**COUGAR CREEK
DEBRIS FLOOD RETENTION STRUCTURE**

**Supplemental Information Request Round 2
Water Act File No. 00384210
NRCB Application No. 1601**

SUBMITTED TO:
Alberta Environment and Parks
and Natural Resources Conservation Board

SUBMITTED BY:
Town of Canmore

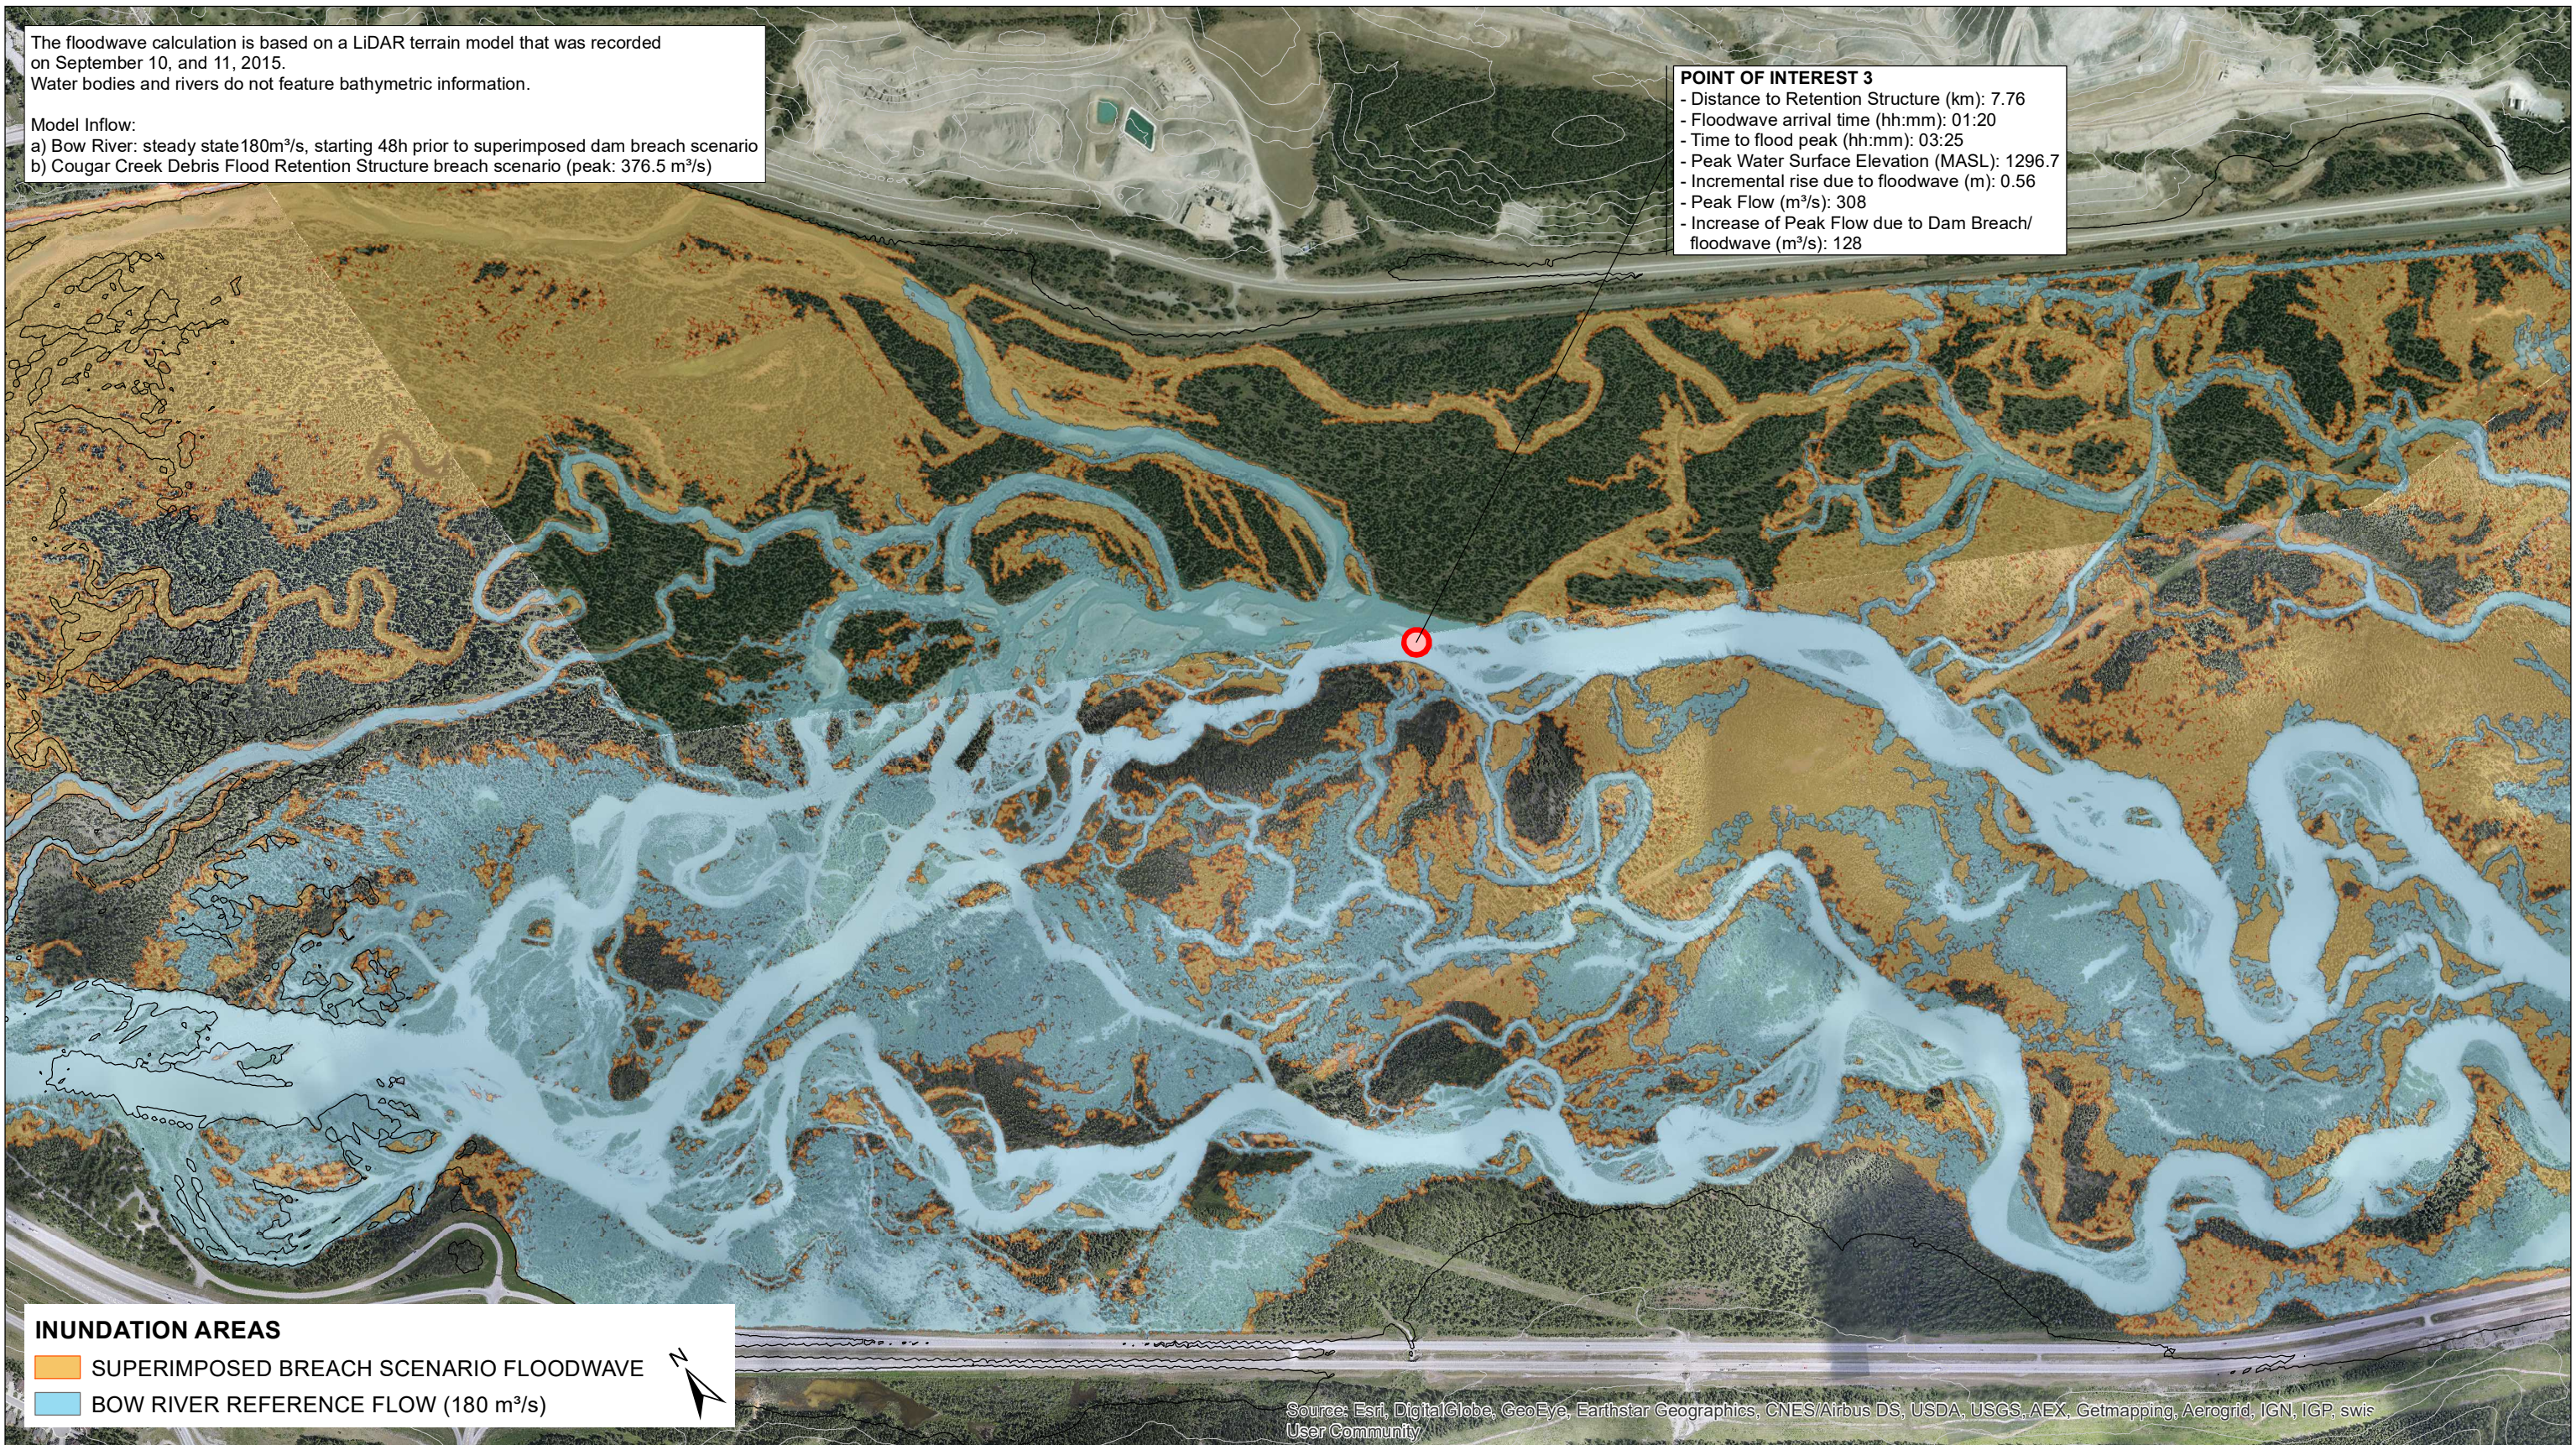
9	Final Terms of Reference, Incidents, Malfunctions and Retention Structure Safety, 7[G] a. Provide information on the potential downstream effects of a dam failure beyond the Town of Canmore. Potential effects to downstream municipalities and additional stakeholders, such as the Stoney Nakoda Nation and the Bow River Basin Council, should be added to cover off their concerns. If no concerns are expected, make the statement.
---	--

Dam breach analyses are regularly conducted downstream of dams until the incremental flood water rise is less than 30 cm. This approach ensures better consistency between different analyses instead of using a fixed distance downstream of a dam breach. The Cougar Creek dam breach analysis has been conducted well past that standard threshold to ensure that the Kananaskis Dam would not fail due to cascading effect (refer to the updated dam breach maps on Figures 9-1 to 9-7). The peak flow of the dam breach is calculated to be 376.5 m³/s at the Structure.
